Market Change Request

Number		Title	Priority
MCR	0093	Amendments to MPD 33 (Single point Unmetered Change of Supplier) to satisfy new requirements for SEM Implementation.	<i>HIGH</i>

Date	Version	Reason For Change
24/10/2006	1.0	Draft for IGG Review
15/11/2006	1.1	As detailed in "Responses to AIP MCR Comments". Ref. 4, 5, 7, 75

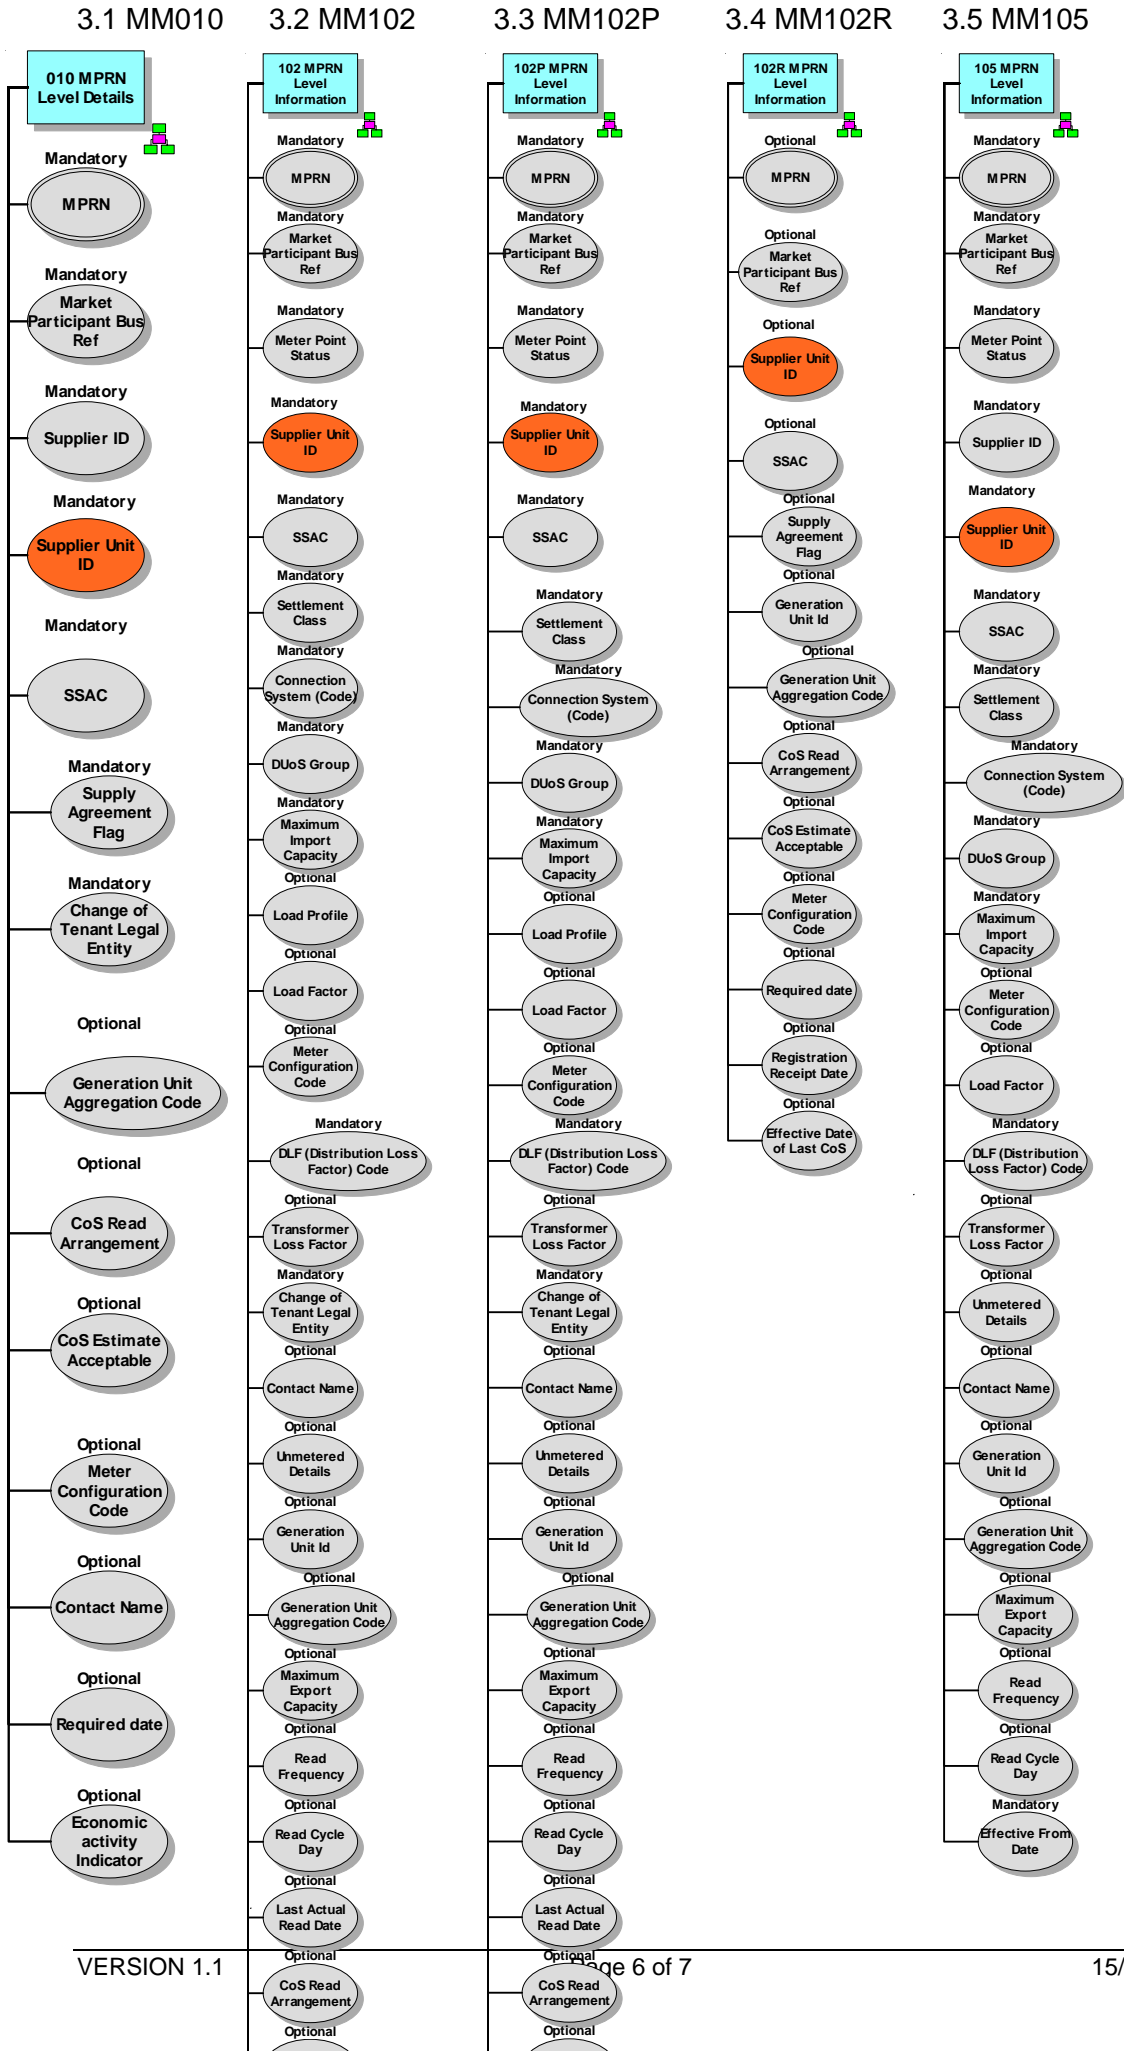
“Supplier Unit” will be added to the 010, 102, 102P, 102R and 105 Market Messages and Generation Unit ID removed from the 010, as follows:-
